From: Buchan Rum Architects <info@buchanrumarchitects.co.uk>
Sent: 24 August 2023 15:01
To: Andy Watt
Cc: Emma Buchan; Emily Hatton
Subject: RE: DM/23/0140 - 68-70 Church Walk, Burgess Hill RH15 9AS
Attachments: M&Co - PL_100_00 06.pdf; M&Co - PL_101_00 06.pdf; M&Co - PL_102_00 04.pdf; M&Co - PL_103_00 04.pdf; M&Co - PL_104_00 03.pdf; M&Co - PL_105_00 01.pdf; M&Co - PL_106_00 01.pdf; M&Co - PL_107_00 01.pdf; M&Co - PL_108_00 01.pdf; M&Co - PL_400_00 04.pdf; M&Co - PL_401_00 04.pdf; M&Co - PL_500_00 04.pdf; M&Co - PL_501_00 04.pdf

Re: DM/23/0140 – 68-70 Church Walk, Burgess Hill. RH15 9AS

Description: redevelopment of an existing 2 storey commercial building to create four storey mixed use building. Through the addition of new floors over the existing building footprint (with partial demolition of the existing 1st floor) to accommodate 10 no of flats over the top three floors retaining the existing commercial/retail use of ground floor

1:50	A1	
Date	Dn By	
06/2023	BRA	
Drawing number	Rev	
PL_501_00	04

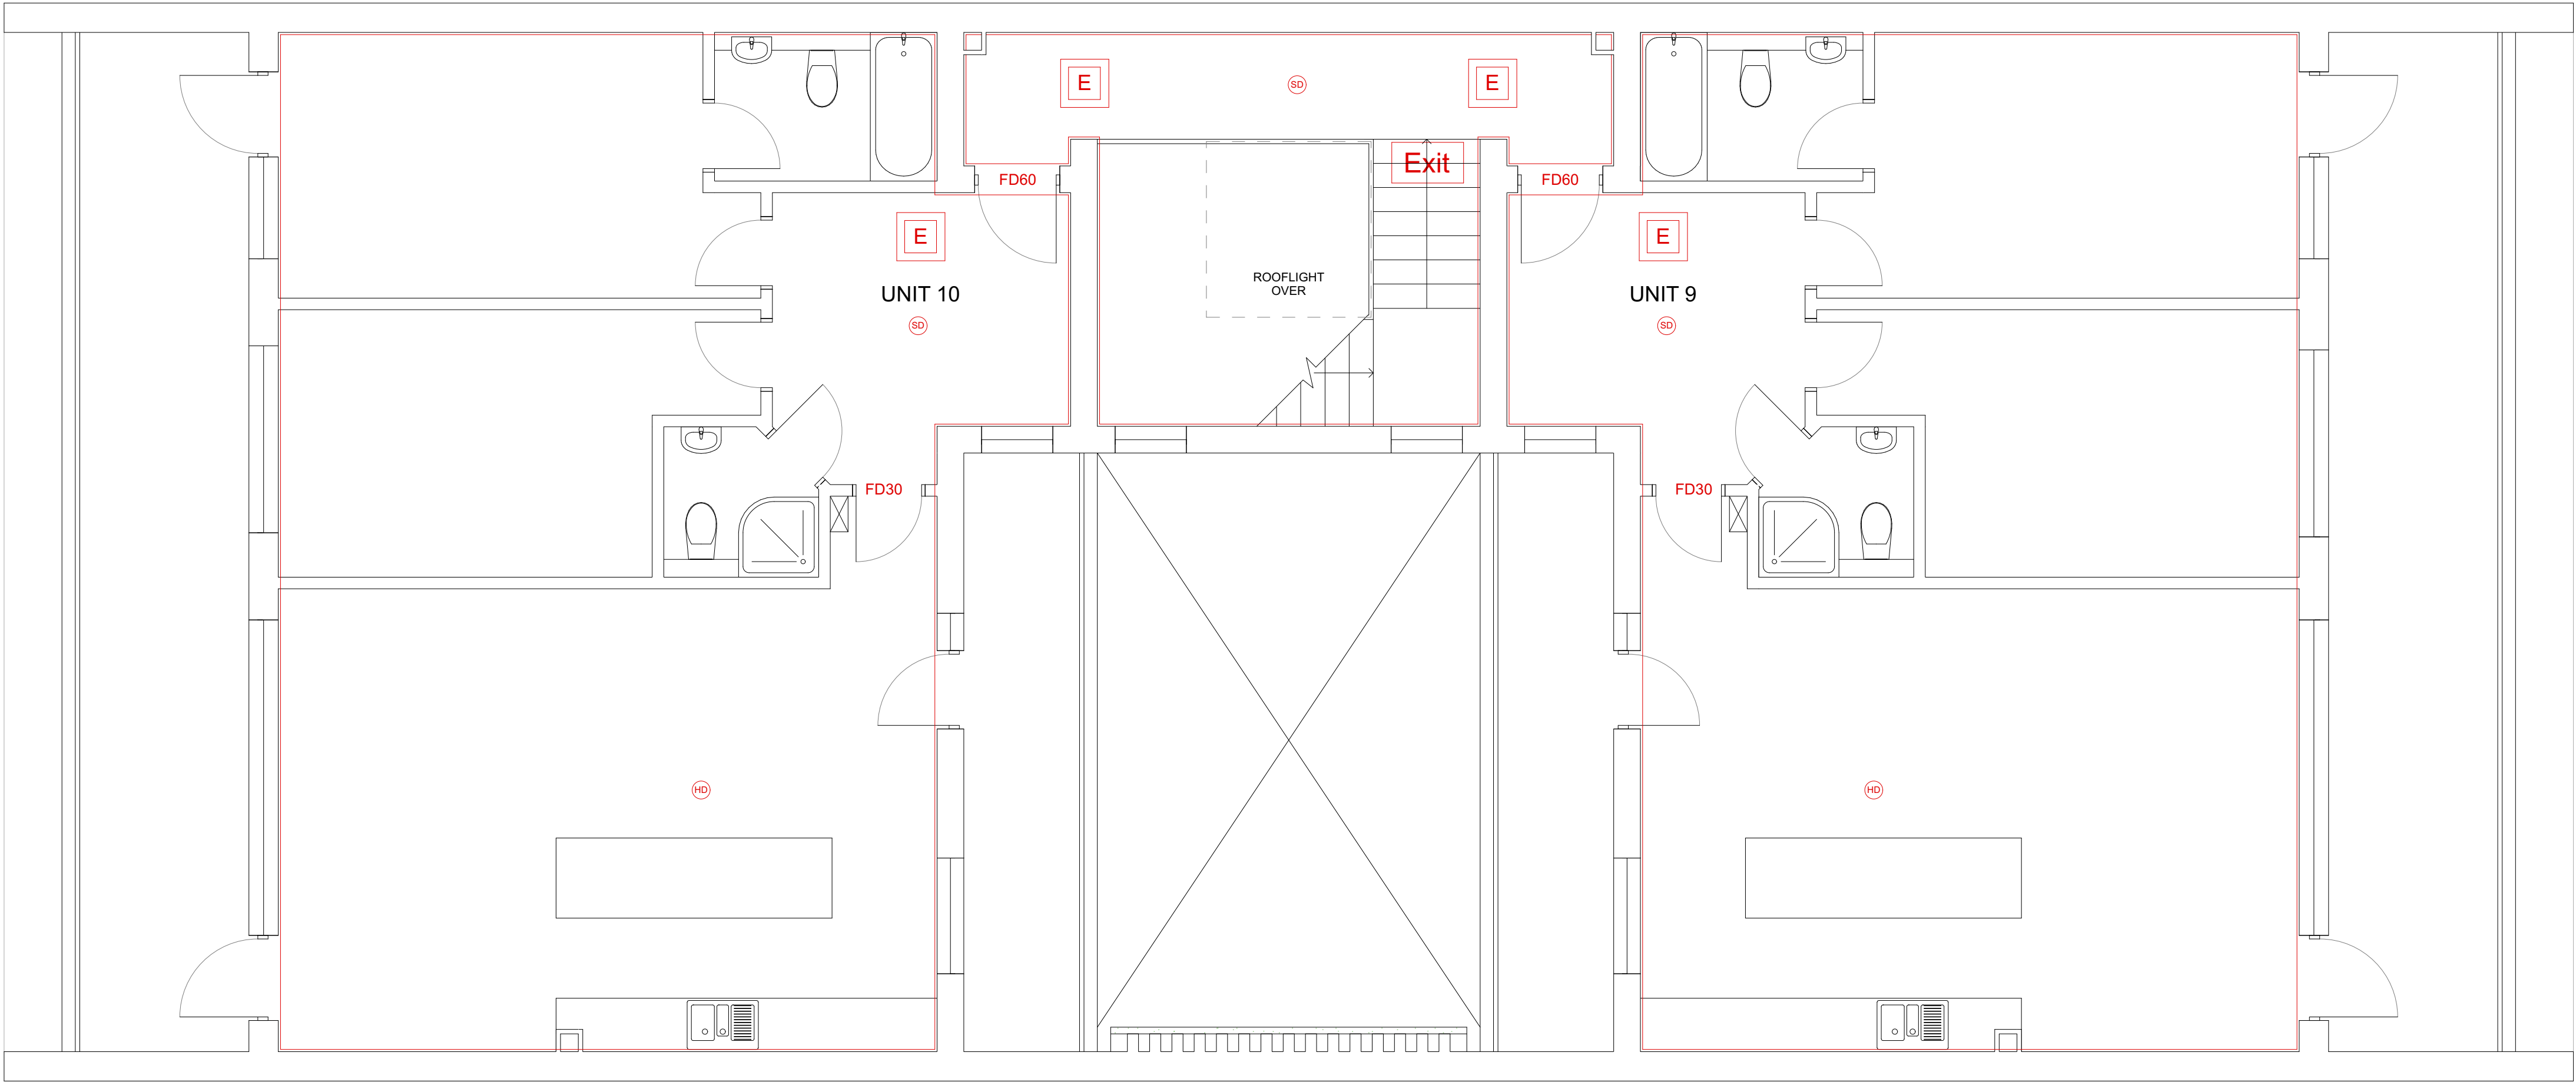
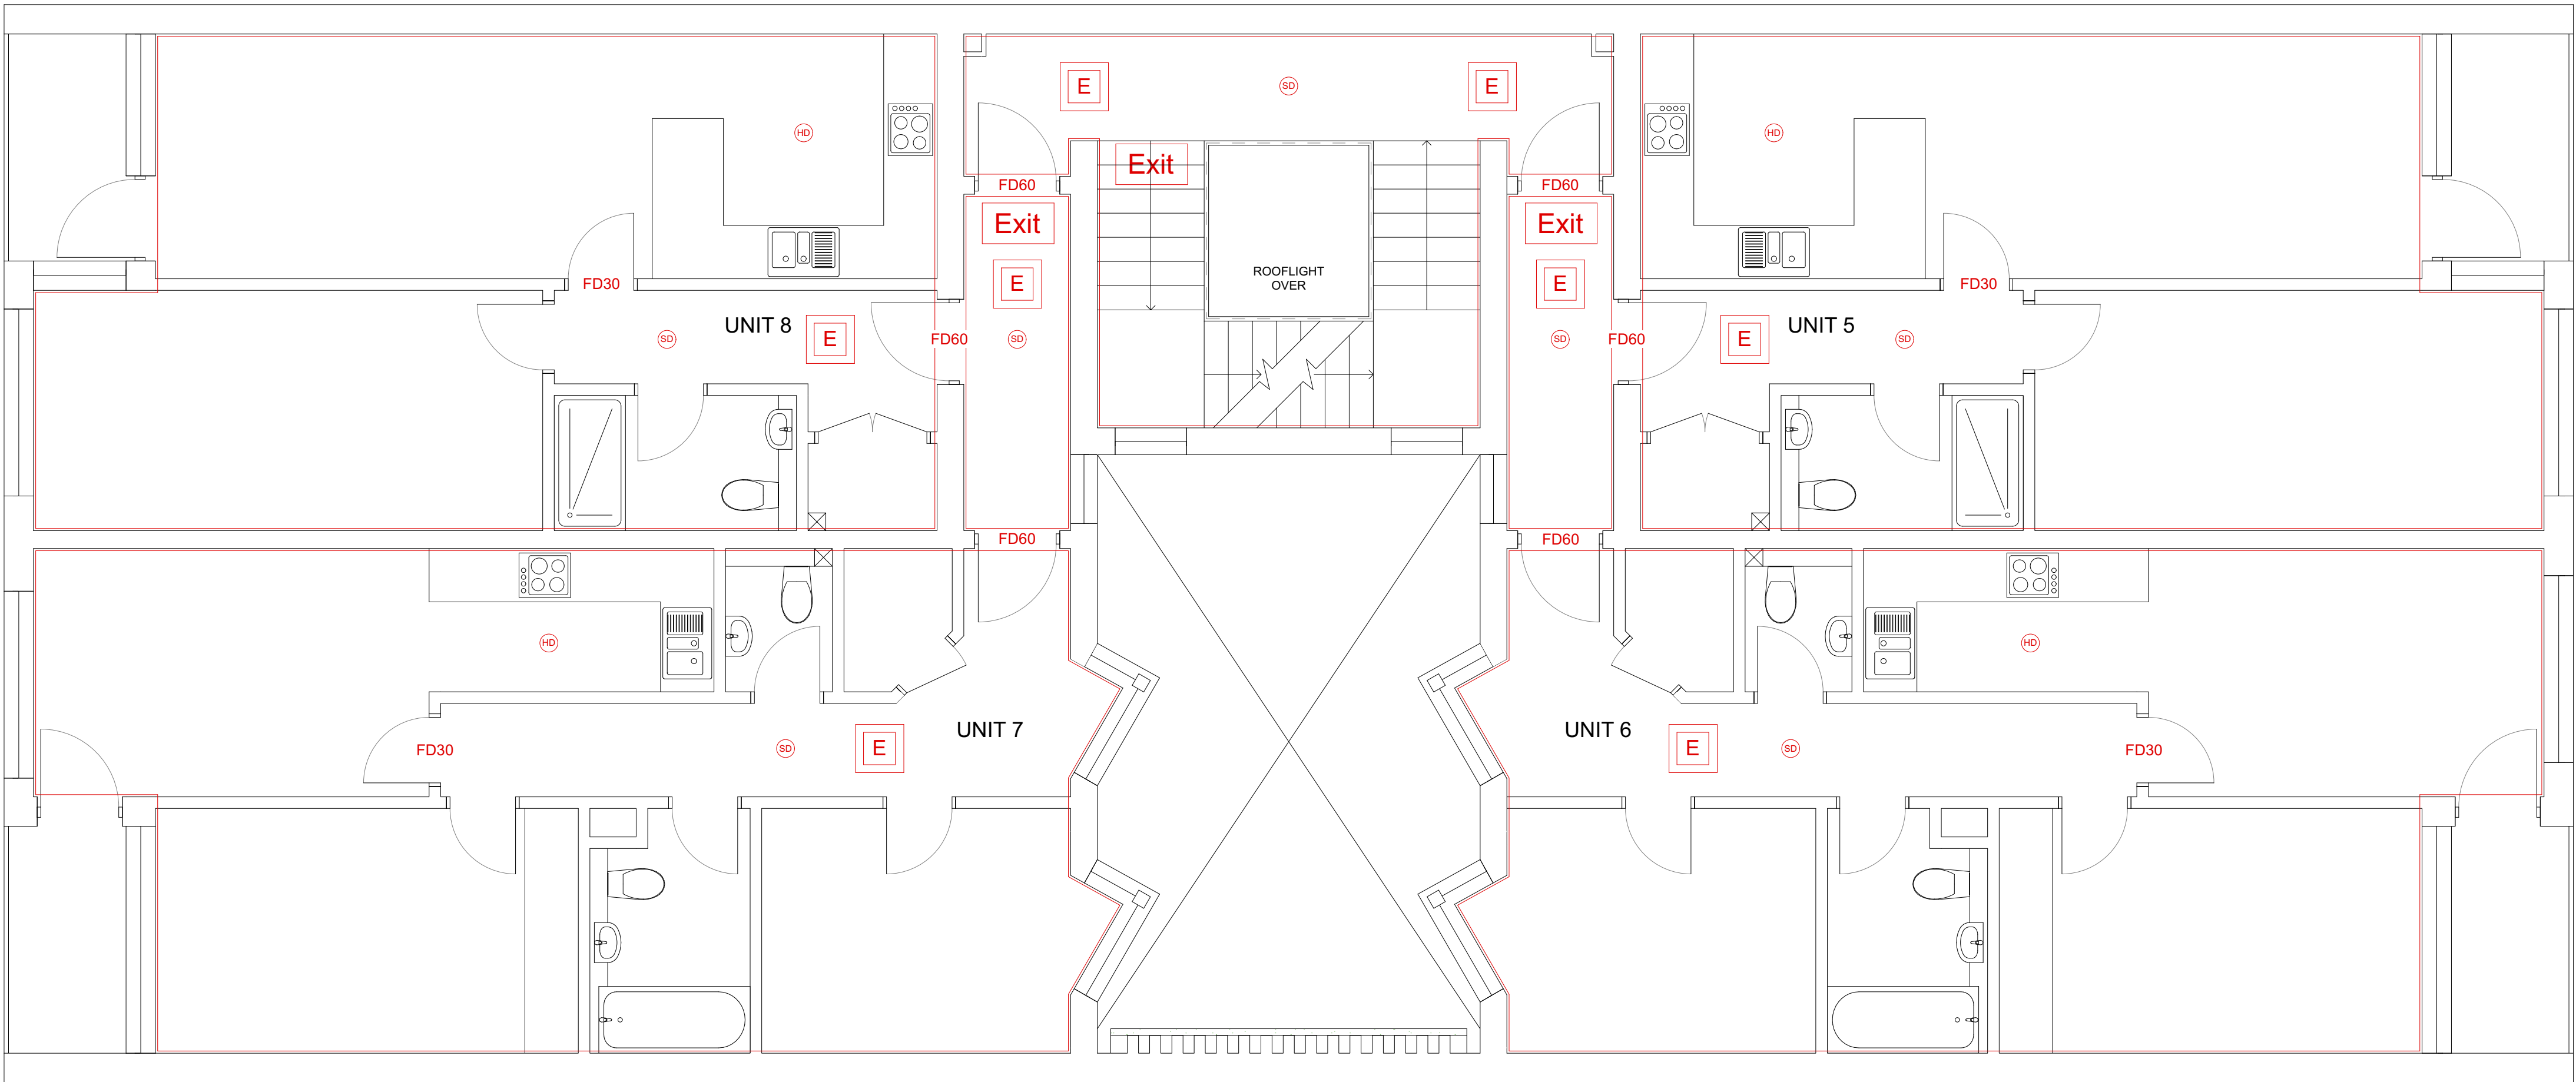
5. Means of escape in case of fire. Provision of 30 Minute fire doors to kitchen and living areas.
6. Interlinked early fire alarm system to whole building with a 30 minute warning system.
7. Suitable and sufficient fire protection and means of escape must be provided including fire doors and interlinked fire alarm systems where appropriate. Escape routes should avoid travel through high risk rooms, namely, bedrooms accessing out of the accommodation past open plan kitchens.
8. Liaison with the Fire And Rescue Service may be appropriate to ensure the fire safety in place links with all the flats. Also to ensure there is sufficient fire protection between the commercial units and the residential above.
9. Balconies require a 60 minute fire protection.

1. Fire doors to kitchen and living areas – 30 minute fire doors shown.
2. To confirm an interlinked early fire alarm system to whole building with a 30 minute warning system will be installed.
3. Escape routes do not travel through high risk rooms.
4. All materials used on balconies will have a 60 minute fire protection
